UNITED STATES
DEPARTMENT OF THE INTERIOR
BUREAU OF LAND MANAGEMENTFORM APPROVED
OMB NO. 1004-0135
Expires: July 31, 2010**SUNDRY NOTICES AND REPORTS ON WELLS**
*Do not use this form for proposals to drill or to re-enter an abandoned well. Use form 3160-3 (APD) for such proposals.***SUBMIT IN TRIPLICATE - Other instructions on reverse side.**

1. Type of Well <input type="checkbox"/> Oil Well <input checked="" type="checkbox"/> Gas Well <input type="checkbox"/> Other		5. Lease Serial No. NMLC063613
2. Name of Operator CHI OPERATING INCORPORATED		6. If Indian, Allottee or Tribe Name
3a. Address MIDLAND, TX 79702		7. If Unit or CA/Agreement, Name and/or No.
3b. Phone No. (include area code) Ph: 432-563-3355		8. Well Name and No. WIZARD FEDERAL COM 1
4. Location of Well (Footage, Sec., T., R., M., or Survey Description) Sec 1 T19S R30E NESE 1750FSL 760FEL		9. API Well No. 30-015-31715-00-S1
		10. Field and Pool, or Exploratory BENSON
		11. County or Parish, and State EDDY COUNTY, NM

Operator Name: Chi Operating

Lease Name: Wizard Feat #1

** BLM REVISED ** BLM REVISED ** BLM REVISED ** BLM REVISED ** BLM REVISED **

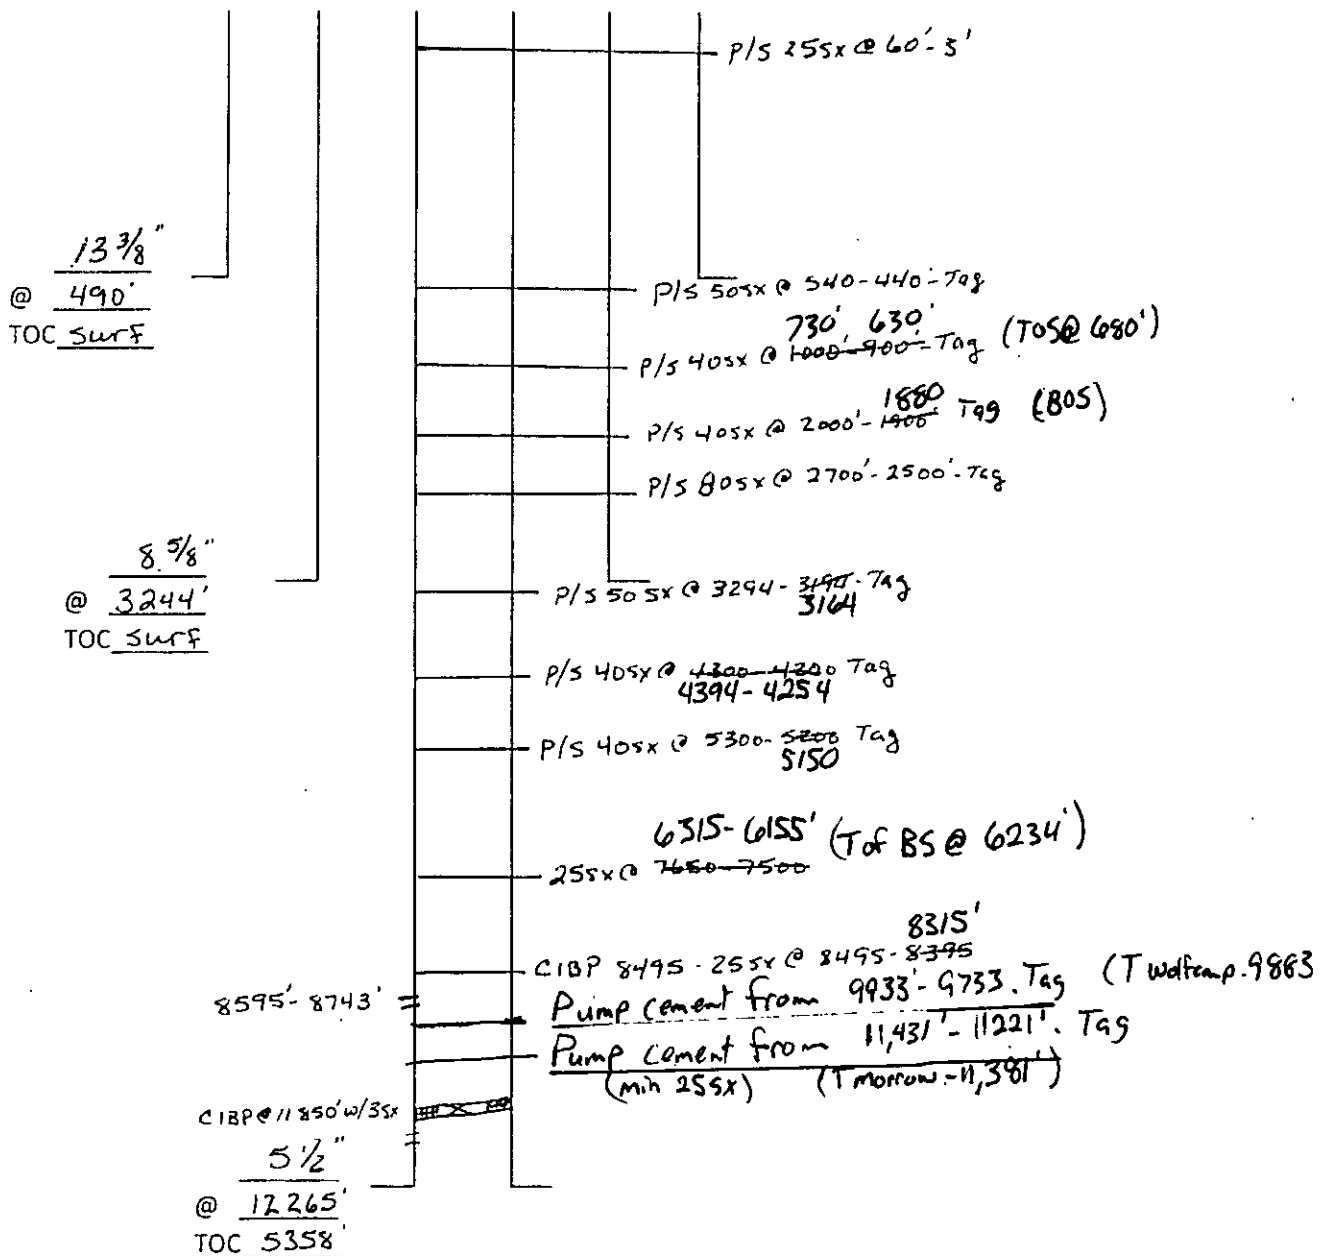
Add 2 Plugs before setting CIBP:

1. Pump 25 sx cmt from 11431' - 11221' Tag
2. Pump 25sx cmt from 9933' - 9733' Tag
